**Project: IEEE P802.15 Working Group for Wireless Personal Area Networks
(WPANs)**

Submission Title: assigned comments for sponsor ballot

Abstract: proposes comment resolutions for a set of sponsor ballot comments

Typical LED frequency response in the visible spectrum

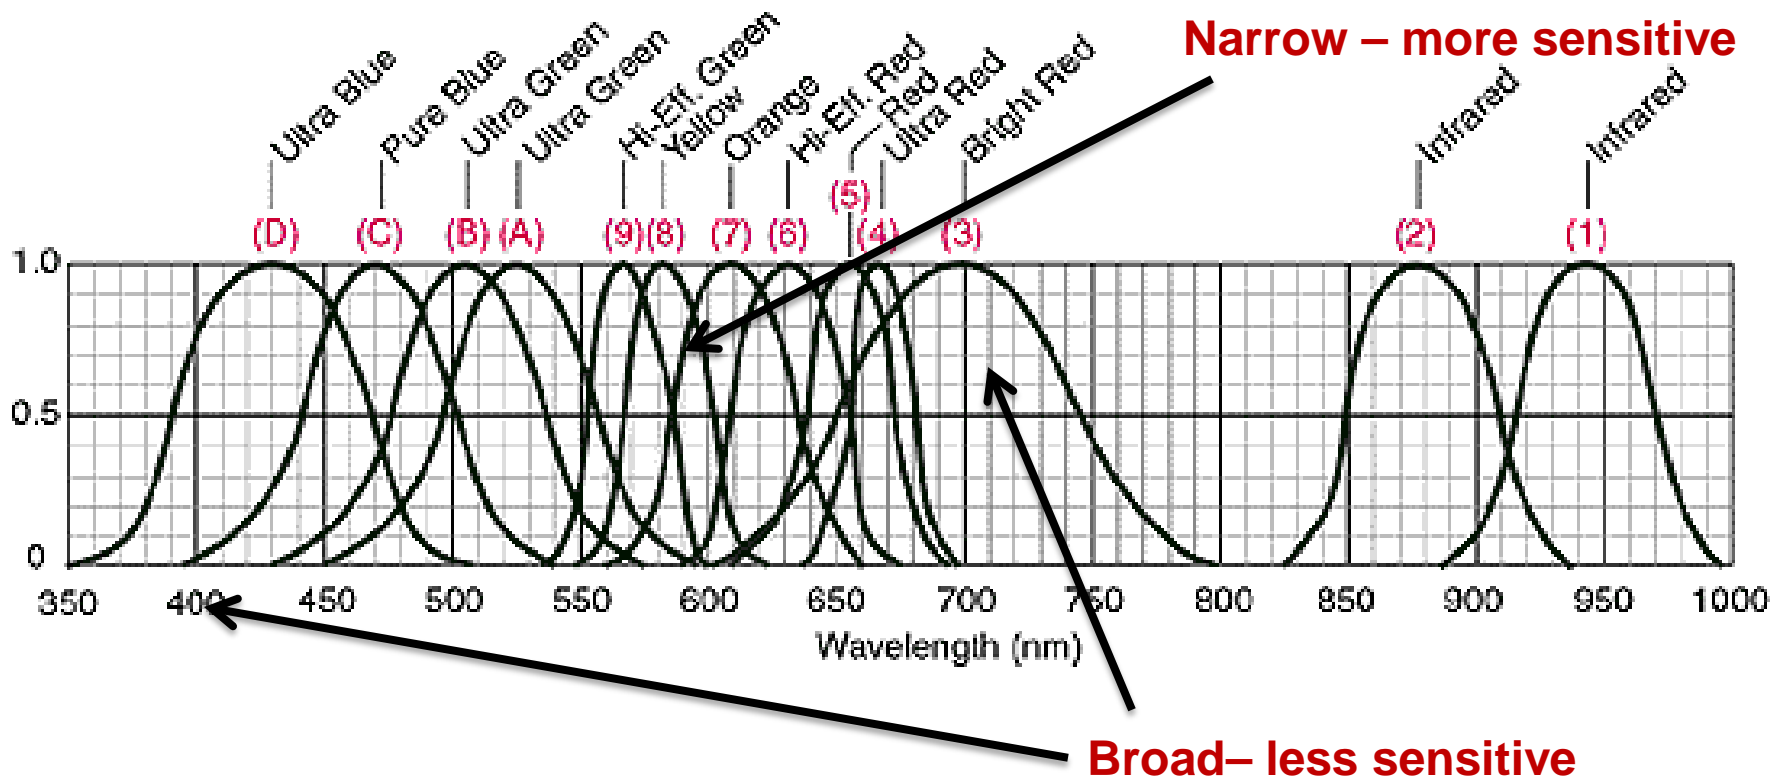
- For band division, another additional novel metric should be used for visible light band division, namely the photo detection responsivity. By using the photo detection responsivity of the receiver device rather than the currently existing metric of the third party (not participating in communication), i.e., human's eye sensitivity, we achieve higher rate performance and more reliable communication, i.e., lower error rates, resulting in approximately 0.05dB rate spectral efficiency gain, or more than 1.1% rate spectral efficiency gain. More importantly, fairness is a key parameter for wireless communications. This division enhances this fairness. The whole band should be divided so that all bands have equal E_b/N_0 value for all subbands and thus results in fairness for all users. Furthermore, simulation shows the superiority of the band division using photo detection responsivity over the band division method using human eye sensitivity. This new division improves reliability performance in a multi-channel environment since it enables a VLC transmitter to maintain a constant transmission range and make the communication link more robust by avoiding a significantly different communication capacity for each subband. While the E_b/N_0 performance varies with respect to the deployed subband (as much as 3.43dB, or more than 2.2 times, difference) using the currently existing band plan, the new plan yields equal performance for all the subbands. Thus the proposed plan ensures fairness among channels (or subbands). Refer to 15-10-0327-00 for more detailed evaluation with simulation results.

Simple change of some numbers will improve the performance and fairness.

- Simply change six numbers in wavelength column and seven numbers in spectral width column in Table 75 as 450 to 478, 510 to 540, 560 to 588, 600 to 633, 650 to 679, 710 to 726 and 70 to 98, 60 to 62, 50 to 48, 40 to 45, 50 to 46, 60 to 47, 70 to 54. And add two words, "photo detectors" after "human eye" in lines 45 and 47 and change "is" to "are" in line 47.

Suggested recommendation for comment 29

Consider bandplan based on current LED transmit characteristics and hence, keep the current bandplan structure

- Wider bands at the edges, narrower at the center

Accept the part about “ and add two words, "photo detectors" after "human eye" in lines 45 and 47 and change "is" to "are" in line 47.”
